Access Compliance Report

Public Rights-of-Way

(Curb Ramps)

Intersection ID: 9637	Main Street: BROWNS_AV	Cross Street: THRIFTWOOD_DR	Location: S
ADA ID: 672B7EB4E5BD	Ramp Type: Perp	Initial Pass/Fail: Fail	Overall Compliance: No
Severity Score: 33.75			
Codes/Mitigation Info/Possible Solution		Field Measurements/Component Compliance

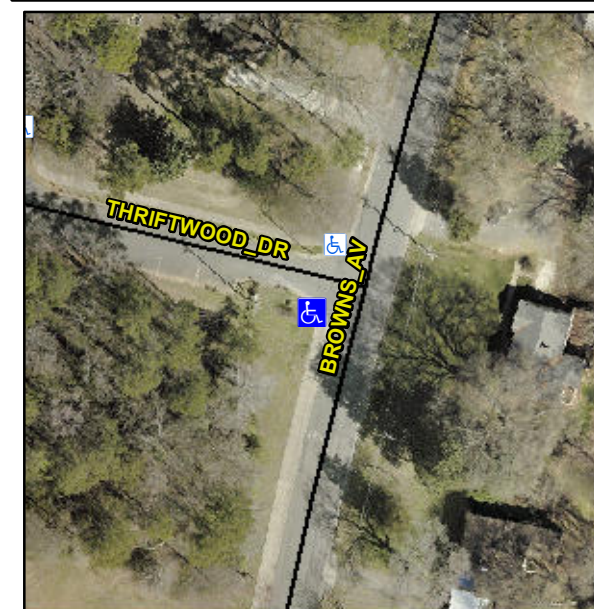
Not Found, R304.5.1, R304.2.2, R304.5.3

Compliance	Description	Data	Compliance	Description	Data
N/A	Ramp Length (in)	73.0	No	Ramp Slope (%)	9.6
No	Ramp Width (in)	46.5	No	Ramp XSlope (%)	6.4
N/A	Flare Type LT	N/A	N/A	Flare Type RT	N/A
N/A	Flare Slope LT (%)	N/A	N/A	Flare Slope RT (%)	N/A
N/A	Flare Traversable LT?	N/A	N/A	Flare Traversable RT?	N/A
N/A	Landing Length (in)	N/A	N/A	DWS Provided?	N/A
N/A	Landing Width (in)	N/A	N/A	DWS Contrast?	N/A
N/A	Landing Slope (%)	N/A	N/A	DWS Length (in)	N/A
N/A	Landing X Slope (%)	N/A	N/A	DWS Full Width?	N/A
N/A	Landing Curb? (Y/N)	N/A	N/A	DWS Offset (in)	N/A
N/A	Shared Landing?	N/A			
N/A	Gutter Ponding?	N/A	N/A	Gutter Slope (%)	N/A
N/A	Gutter Lip Ht (in)	N/A	N/A	Gutter X Slope (%)	N/A
N/A	Painted X Walk1?	No	N/A	Painted X Walk2?	N/A
	X Walk 1 Direction	To N		X Walk 2 Direction	N/A
N/A	X Walk 1 Width (in)	N/A	N/A	X Walk 2 Width (in)	N/A
	X Walk 1 Slope (%)	0.5		X Walk 2 Slope (%)	N/A
	X Walk 1 X Slope (%)	6.1		X Walk 2 X Slope (%)	N/A

Remove & Replace Entire Ramp.
